GRAIN DEALERS BREWERY

100 North 13th St, Bay K
Erwin, NC

PERMIT SET
GRAIN DEALERS BREWERY
100 North 13th St, Bay K
Erwin, NC

LIGHTING PLAN
E2

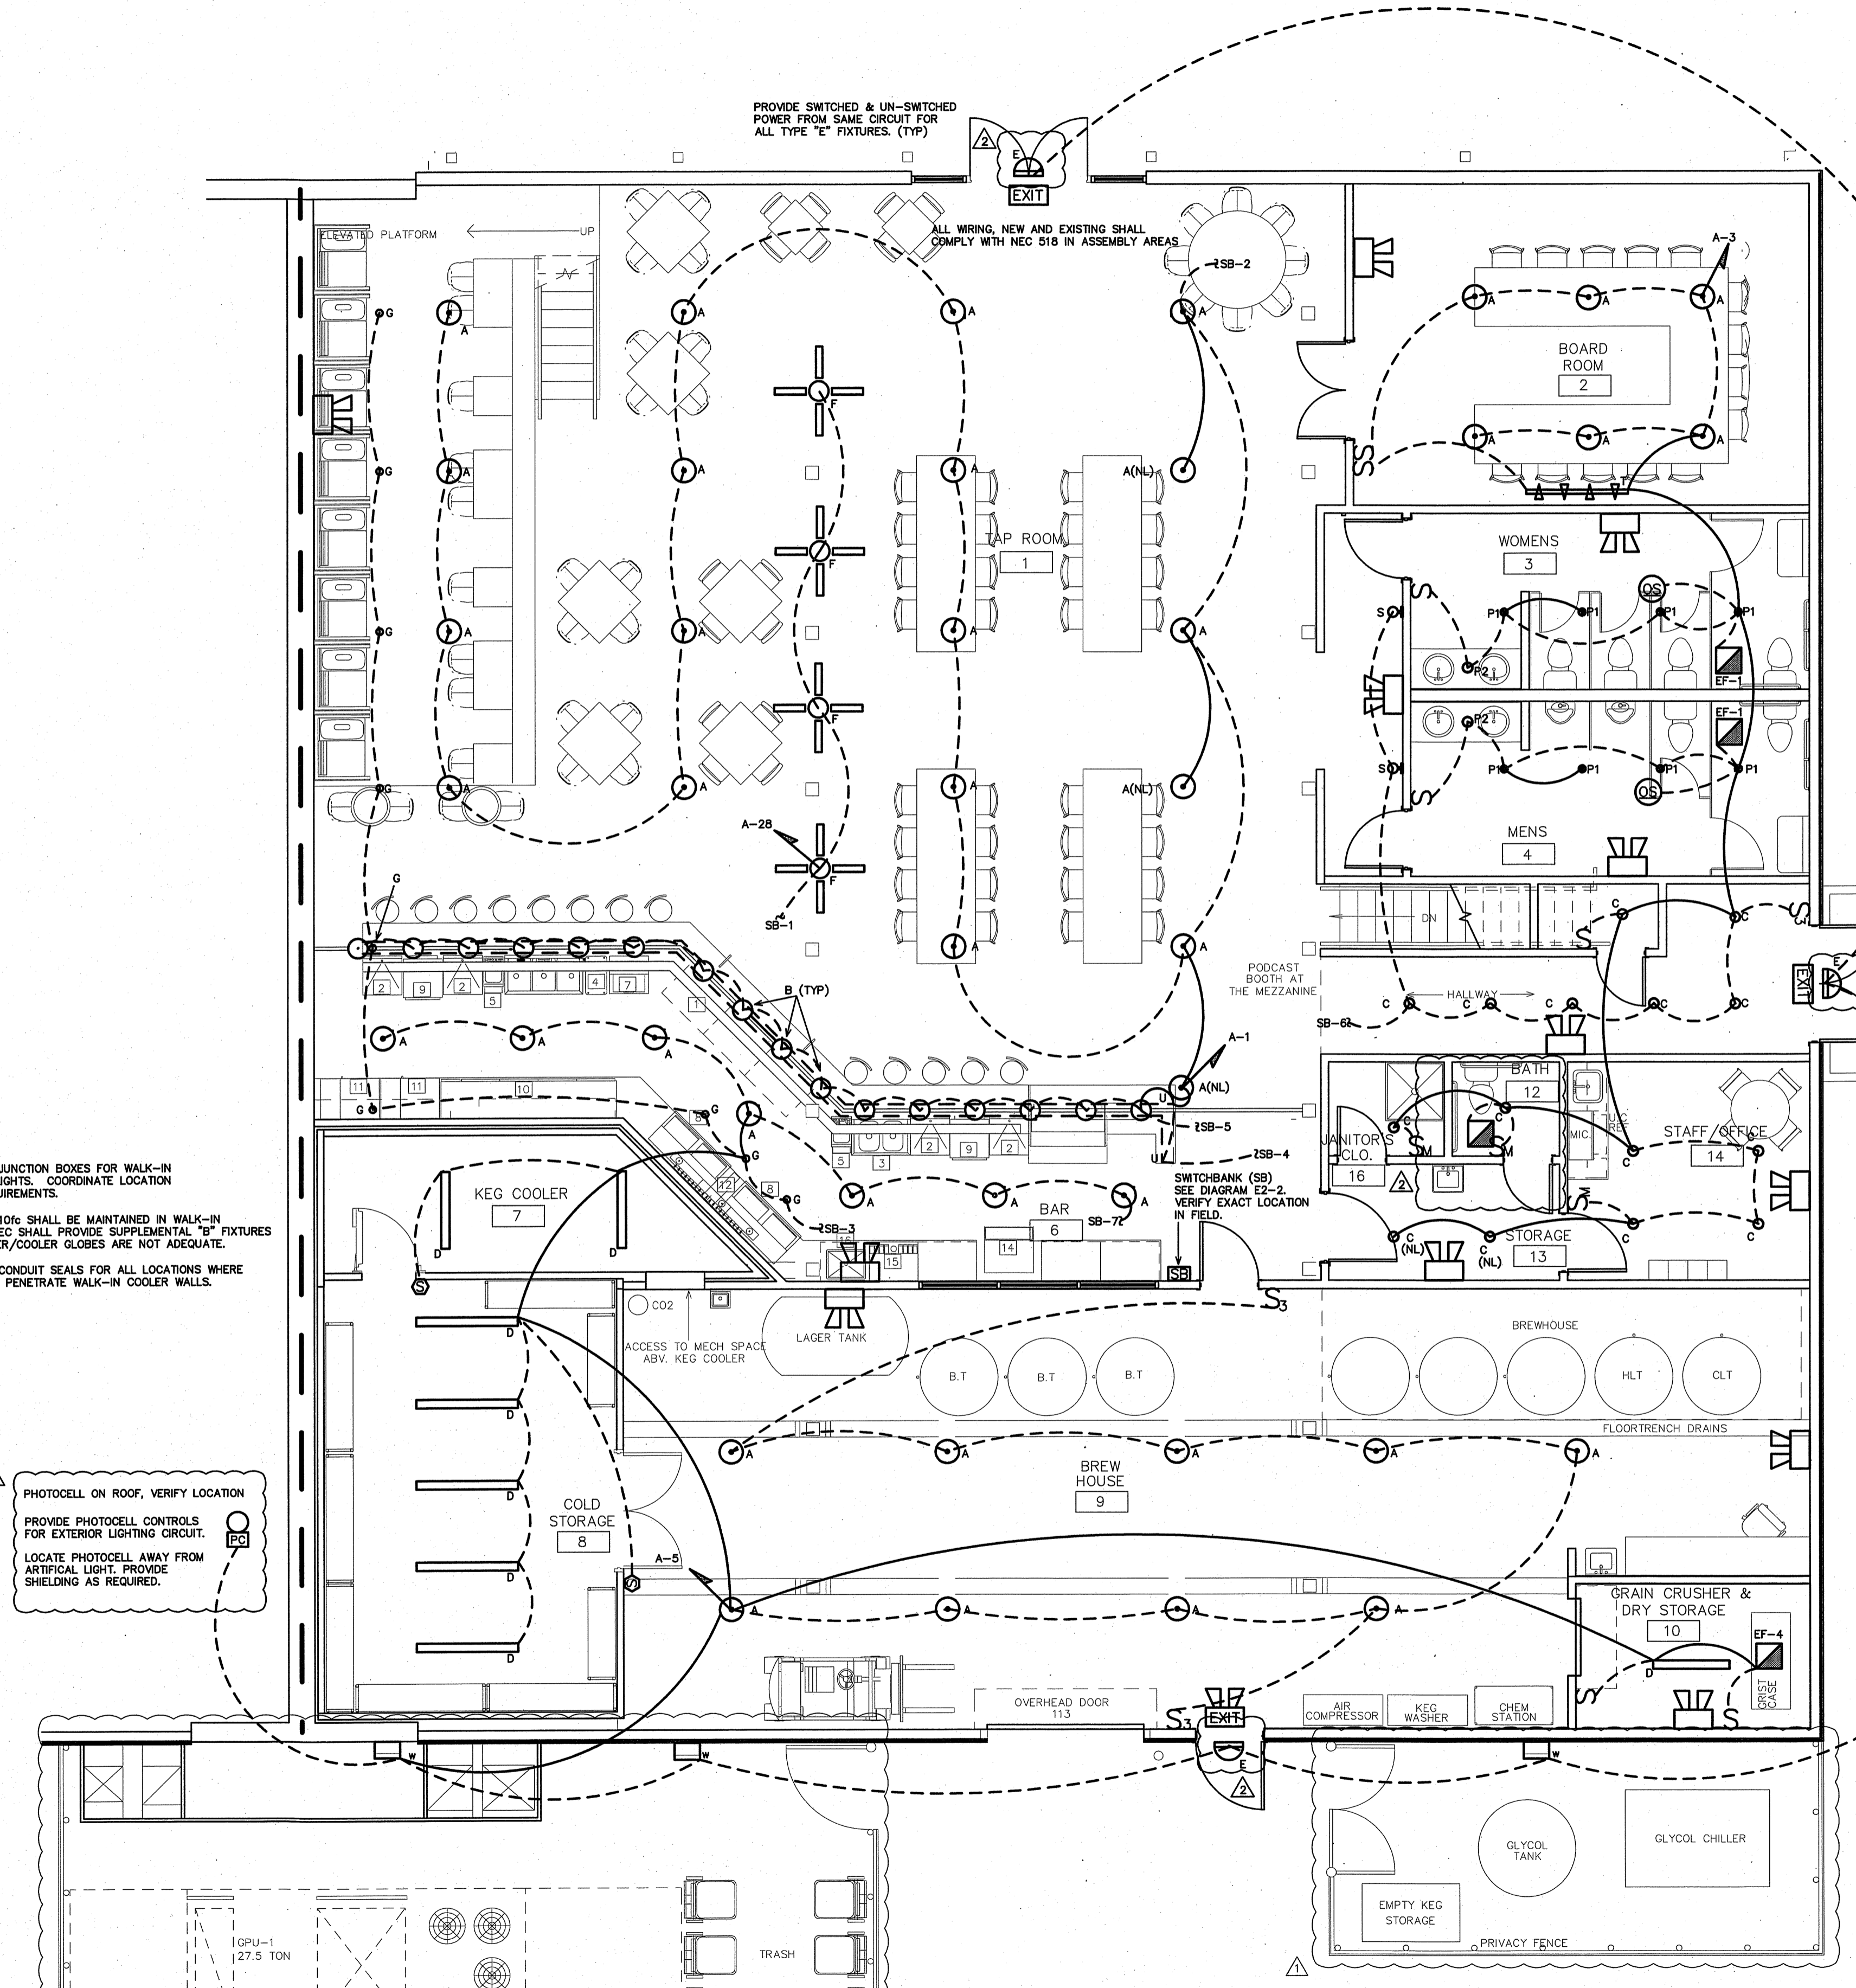
1. Need egress lighting at exterior side of egress doors (battery Backup)
BDG Response: Sheet E2 updated to show 'E' fixtures shifted for clarity. 'E' fixtures are emergency/normal.
2. Lights in podcast booth shown as wall packs on ceiling? Also need emergency lighting in podcast area
BDG Response: Sheet E2 updated to specify 'G' fixtures in mezzanine and to show emergency lighting in podcast area.
3. Panel A schedule shows 100A main for 400 A panel.
BDG Response: Sheet E4 updated to show 400A main in panel 'A'
4. Circuit 2 from main disconnect to first panel "m" does not show a neutral.
BDG Response: Sheet E4 updated to revise riser wiring
